RE: **Oso Bio Syringe Line**  
**4401 Alexander Blvd NE**  
**Grading and Drainage Plan for Building Permit**  
**Engineer's Stamp Date 11/1/2018 Disapproved**  
**Hydrology File: F16D003B1**

Re: Oso Bio Syringe Line Grading Plan Submittal; Hydrology File F16D003B1

Enclosed for your review is a copy of the Oso Bio Syringe Line Drainage Management Plan and Grading Plan Resubmittal. Below is a brief description of how the comments from your letter dated October 23, 2018 were addressed:

TRACT A & B BLOCK 5  
 REPLAT OF TRACT  
 2-A SUNDTS  
 INDUSTRIAL CENTER  
 PRIVATE POND EXHIBIT

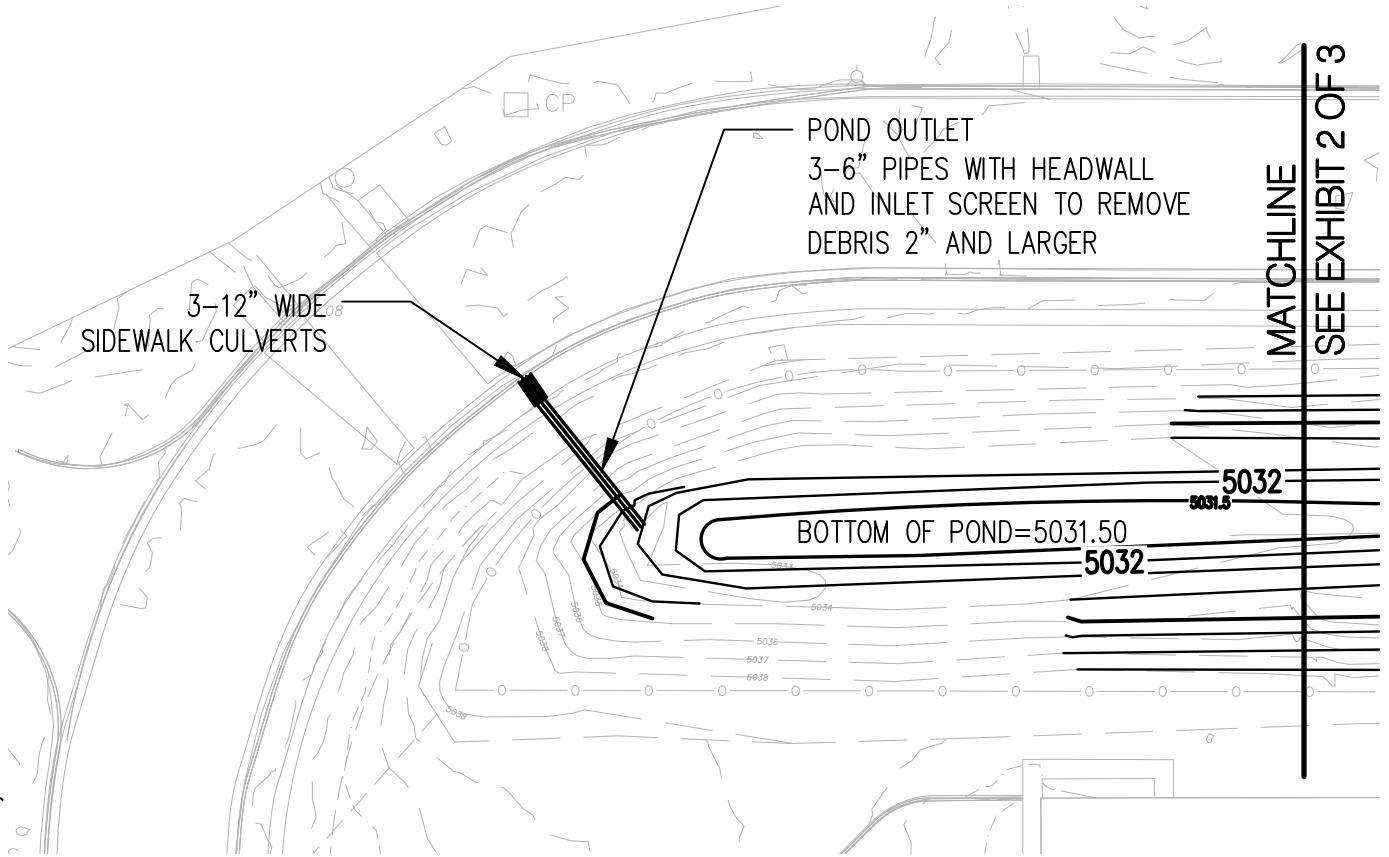
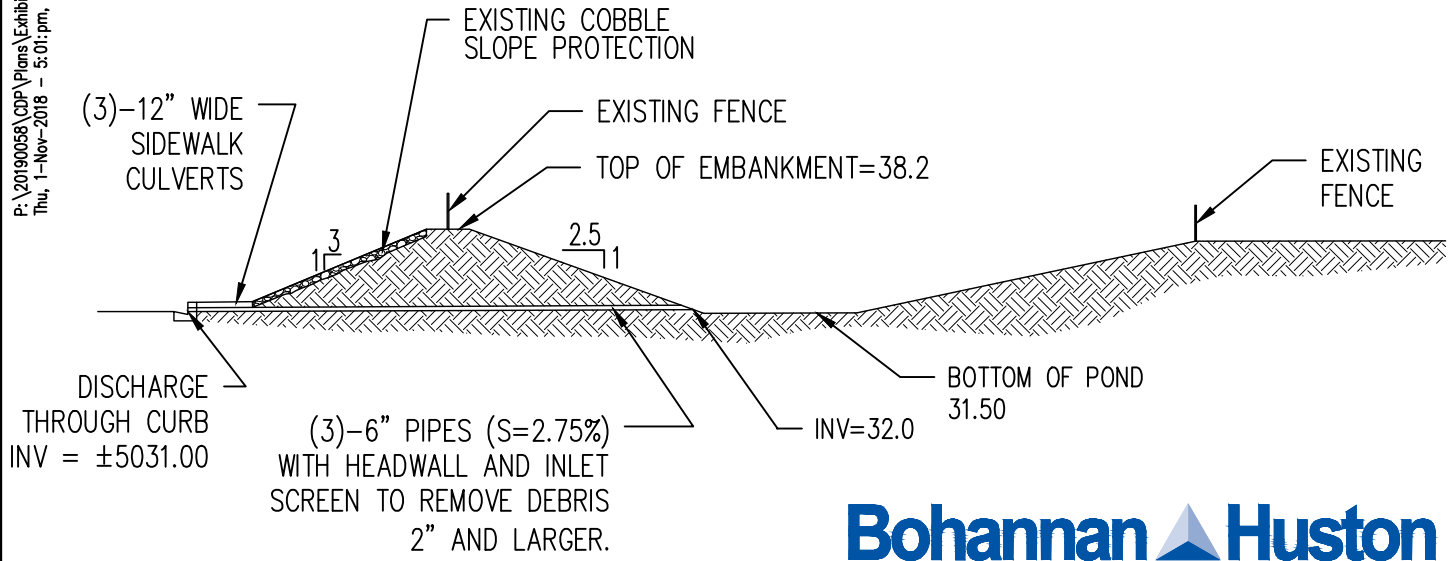
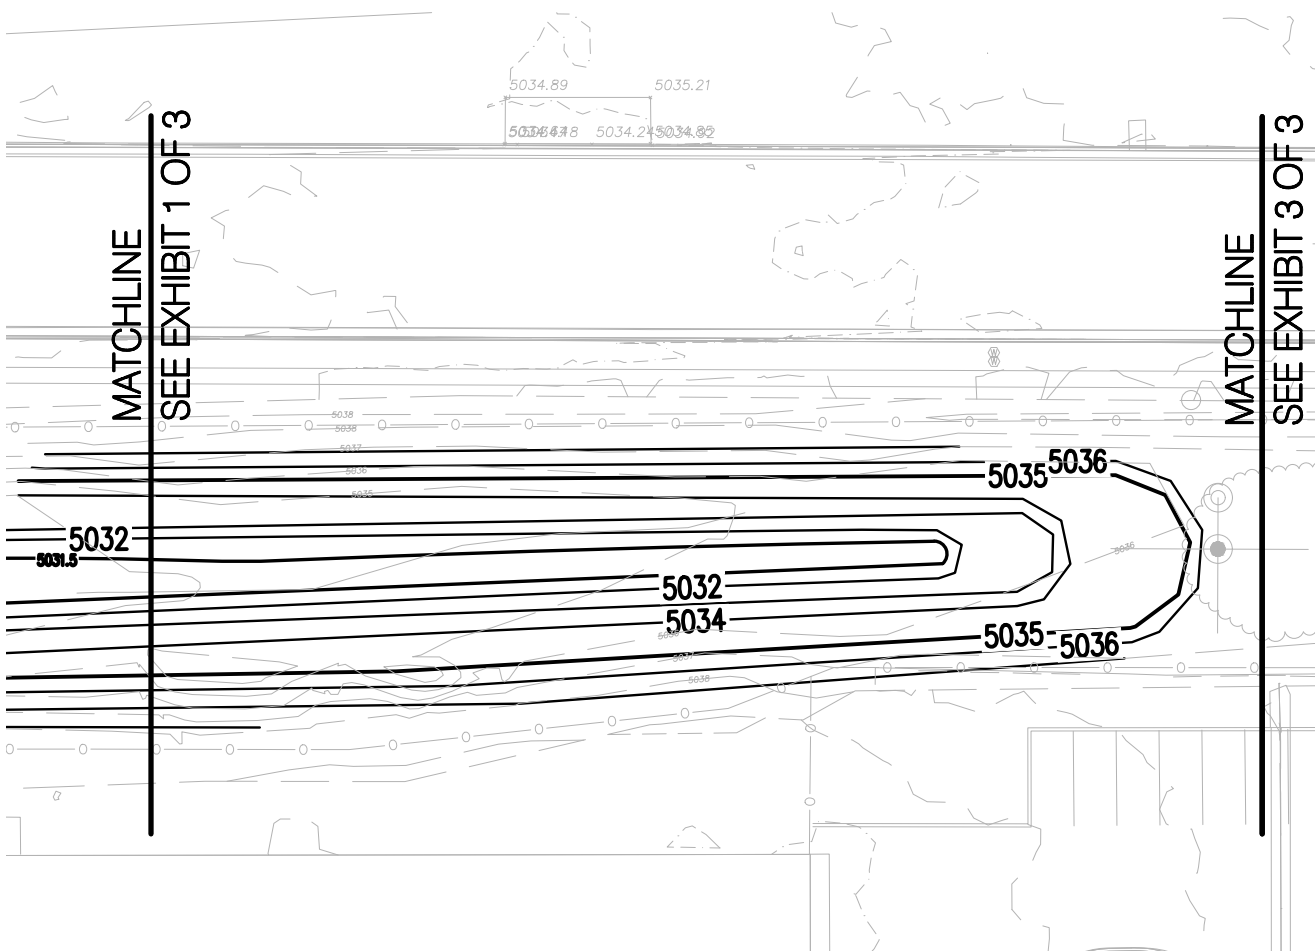
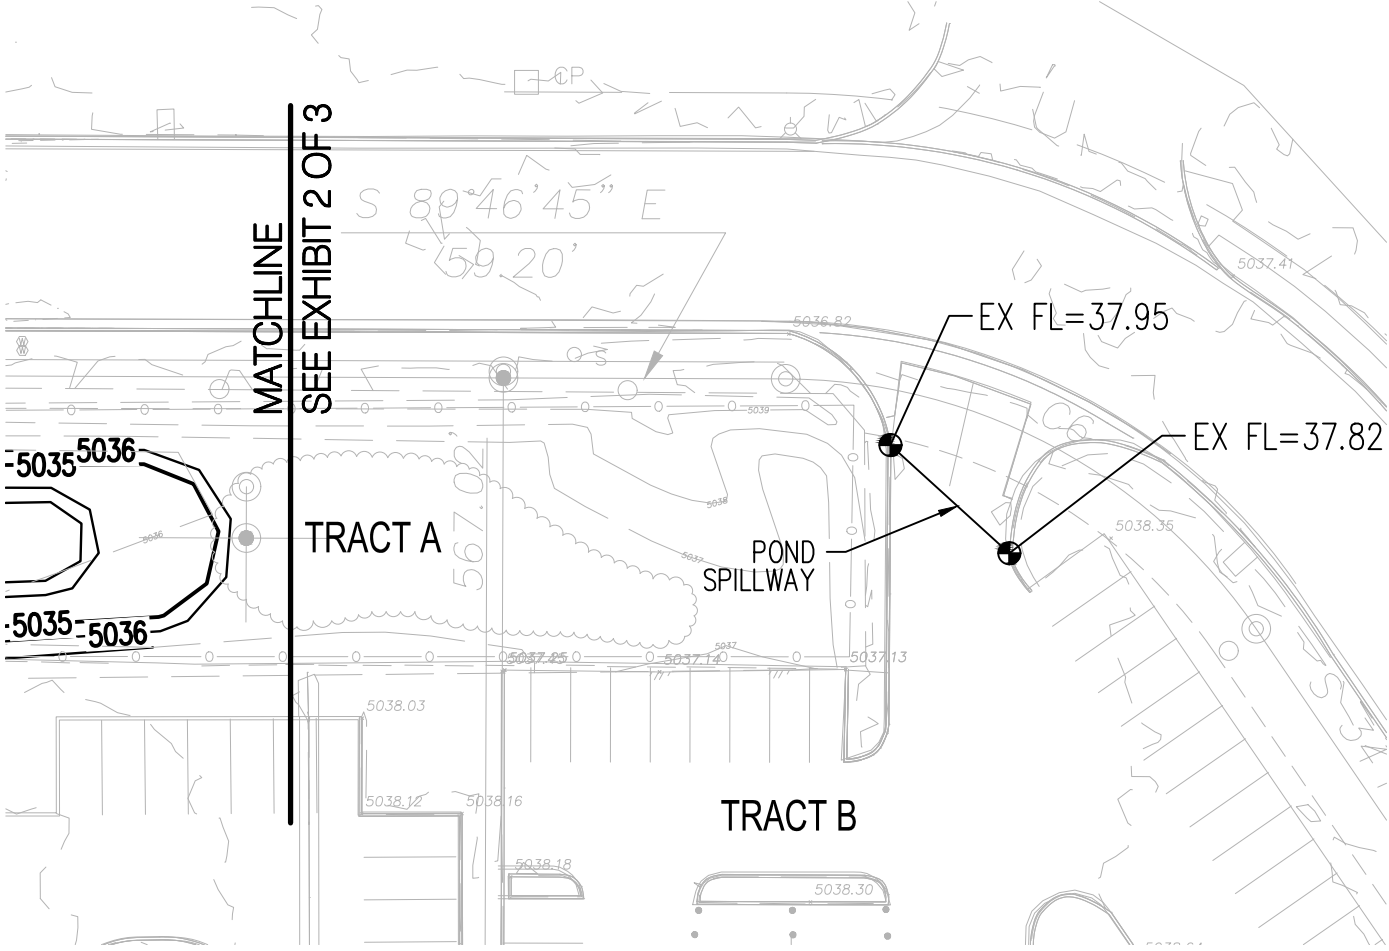
3. Engineer's Certification, per the DPM Chapter 22.7: *Engineer's Certification Checklist For Non-Subdivision* is required. The Engineer's Certification must be placed on the approved Grading and Drainage Plan after the revised plan gets approved. It should include as-built survey information from a registered professional surveyor and a certification statement from a registered professional engineer.
4. The sidewalk culverts must be inspected and approved by storm drain maintenance (Jason Rodriguez, jtrodriguez@cabq.gov or 857-8607).
5. Bernalillo County Recorded Drainage Covenants (No Public Easement) are required for the stormwater control pond (one for each side of the property line). The original notarized form,

7. The drainage covenant exhibit has been modified and approved. There was an error in the pond volume calculations previously submitted. It has been corrected and the HEC-HMS model updated. The volume has been updated on the attached drainage covenant exhibit. We are in the process of getting the owners signature on the document. The original and filing fee will be submitted to the City once we receive it.
